STMO Bn, LLC (Starfire)
Responses to Siting Board Staff's First Request for Information
Case No. 2024-00255

**Starfire Solar Project
Knott, Perry, and Breathitt Counties,
Kentucky**

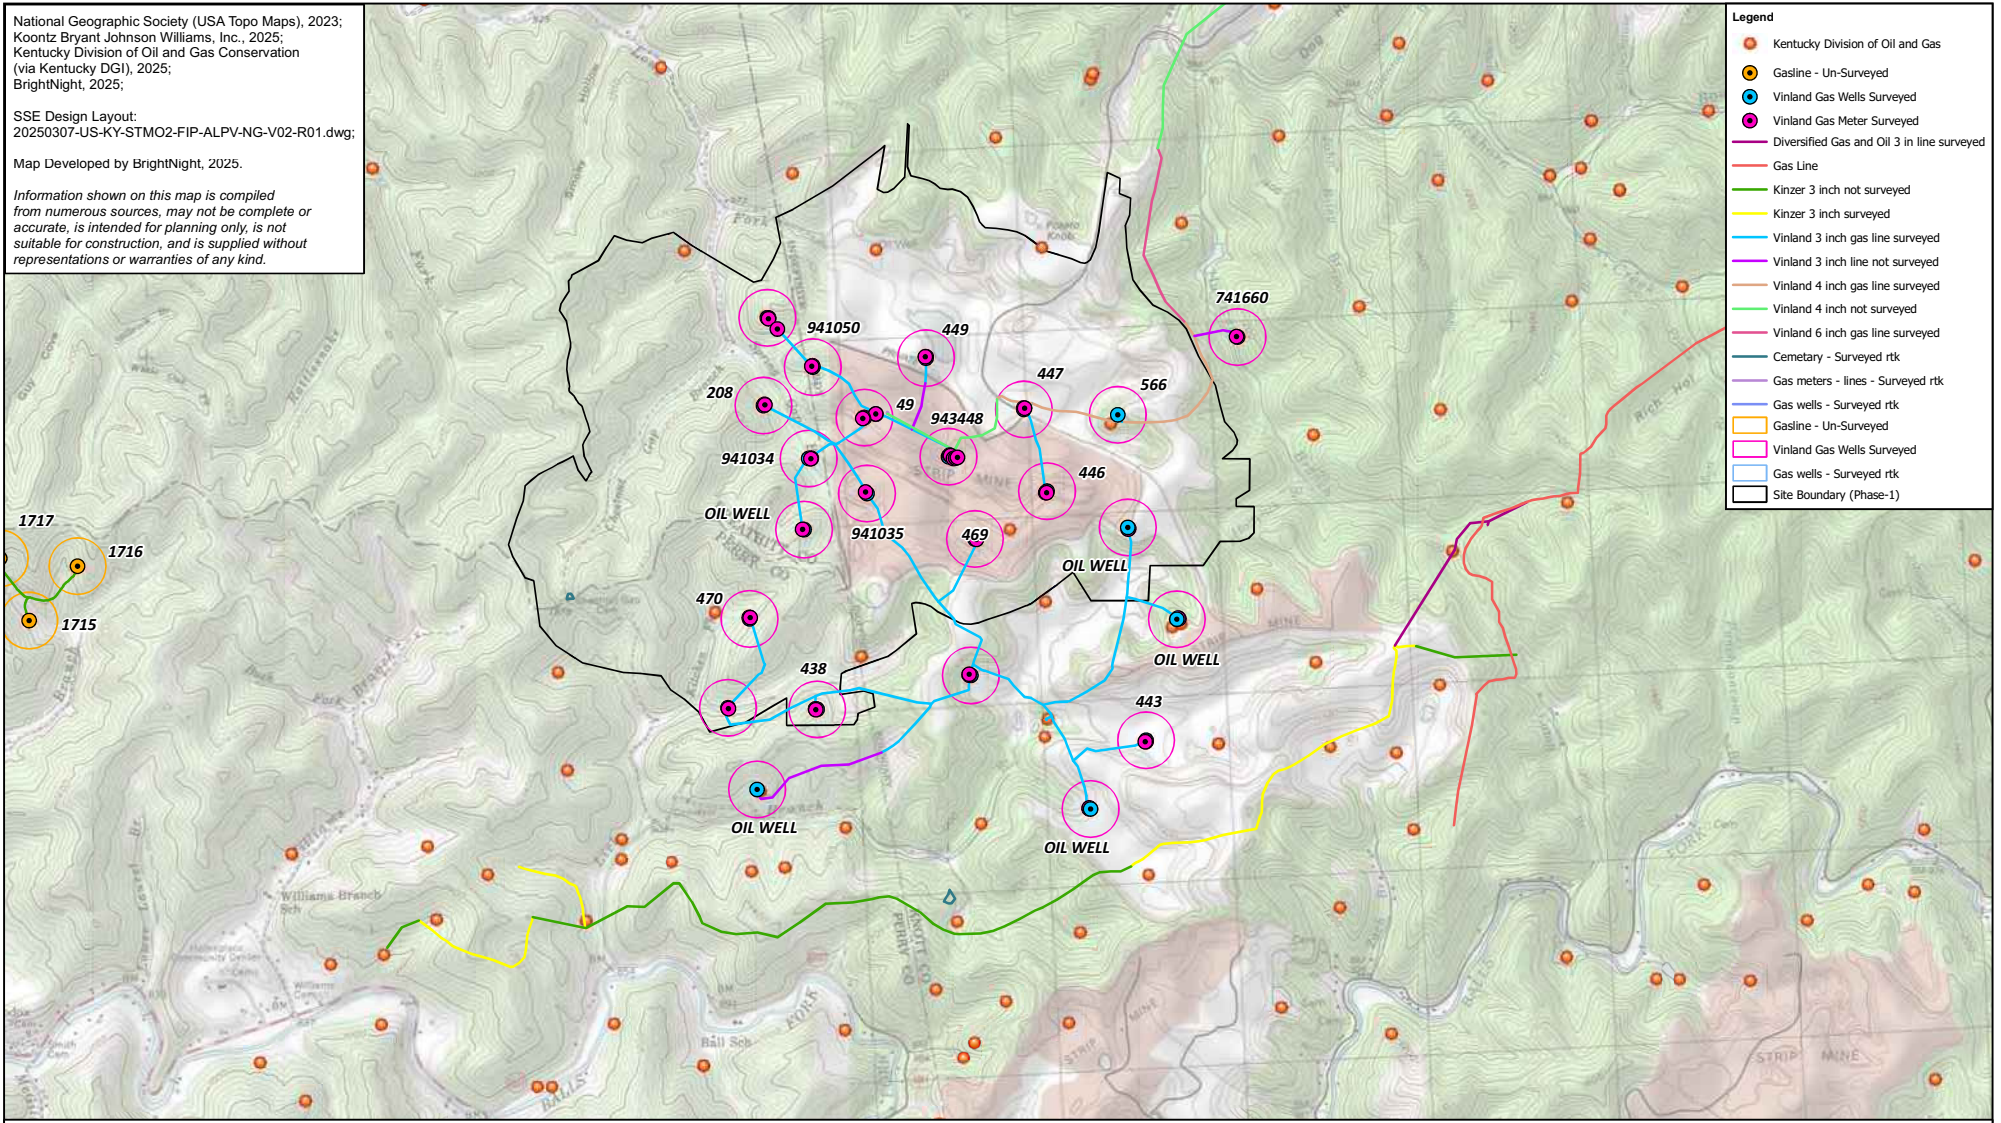
Identify the gas pipeline included in the legend of the site plan. In the response include the owner of the pipe, diameter of the pipe, and provide a map showing its location within the project boundary.

The pipelines in the legend of the site plan are owned by Vinland Gas and are narrow diameter (6 inch or less) gas gathering pipelines. Please refer to map provided for Request No. 17 for locations within the project boundary.
